ACTION TRANSMITTAL No. 2018-25

SUBJECT: Scope Change Request for St. Paul's Expo Area Schools Safe Routes to School Project

Subject: Scope Change Request
Expo Safe Route to School Improvements
SP 164-591-002
City of Saint Paul

PROJECT MAP

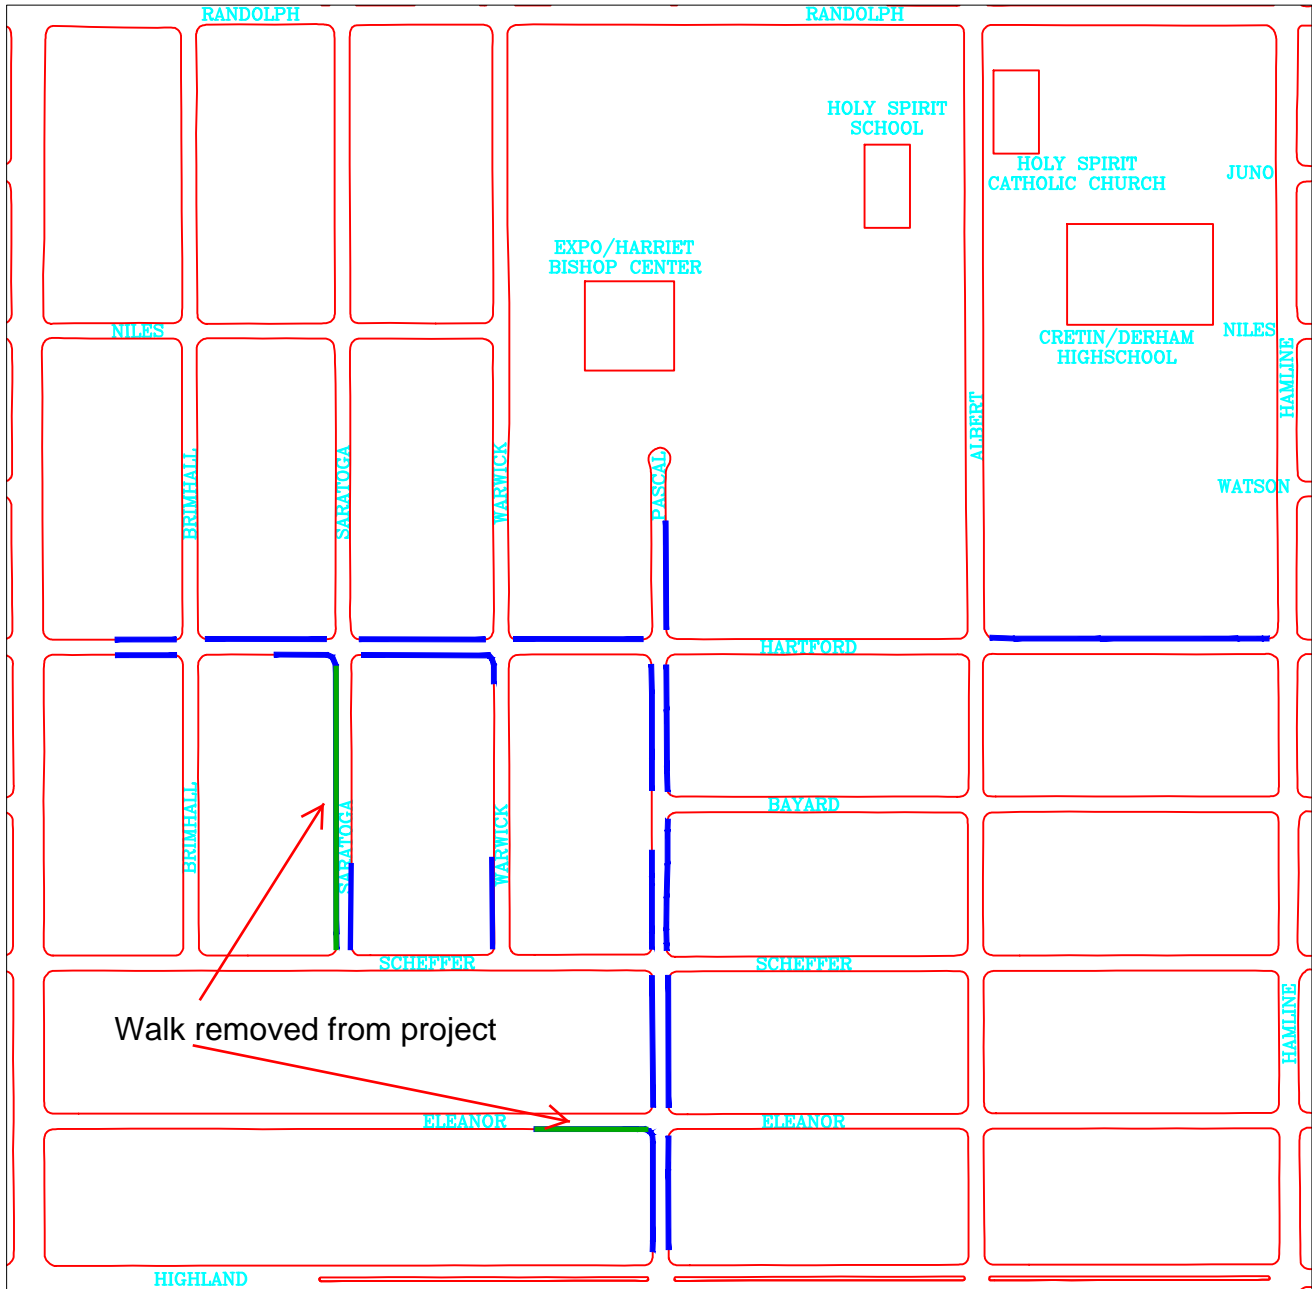
Two segments of sidewalk a being proposed for removal on the Expo SRTS project. The attached map shows the portions of sidewalk being removed. The portions are the west side of Saratoga between Hartford and Scheffer (6' wide and 484' in length) and the south side of Eleanor between Snelling and Pascal (6' wide and 443' in length). These segments require extensive grading, a number of driveway replacements, a number of step replacements and will have a major impact on the existing trees in the neighborhood. The community has identified Pascal and Hartford as the priority corridors for sidewalk for Safe Routes to School and would rather have the segments of Saratoga and Eleanor removed from the project than impact the trees in the area. It should also be noted that sidewalk currently exists on the opposite side of these street so a SRTS route is being maintained along these streets. The total sidewalk length being removed is 927' at an estimated cost of \$86,461. The new estimated construction cost is \$599,424.

Walk removed from project
